FINAL PRODUCT/PROCESS CHANGE NOTIFICATION #20184AGeneric Copy

Issue Date: 06-Nov-2013**TITLE:** Final PCN of change of die coating material in HIC**PROPOSED FIRST SHIP DATE:** 06-Feb-2014**AFFECTED CHANGE CATEGORY(S):** Die coat material**FOR ANY QUESTIONS CONCERNING THIS NOTIFICATION:**

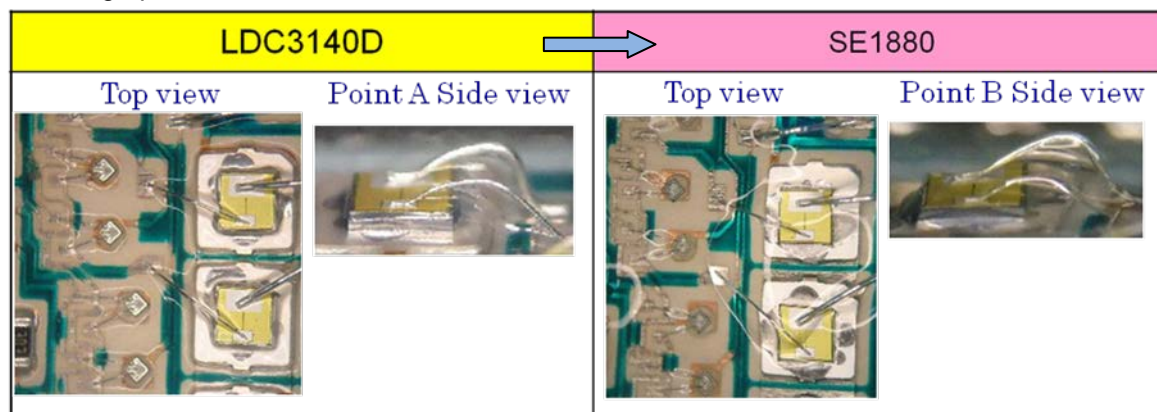
1. RoHS

LDC3140D	SE1880
RoHS	Compliance	Compliance
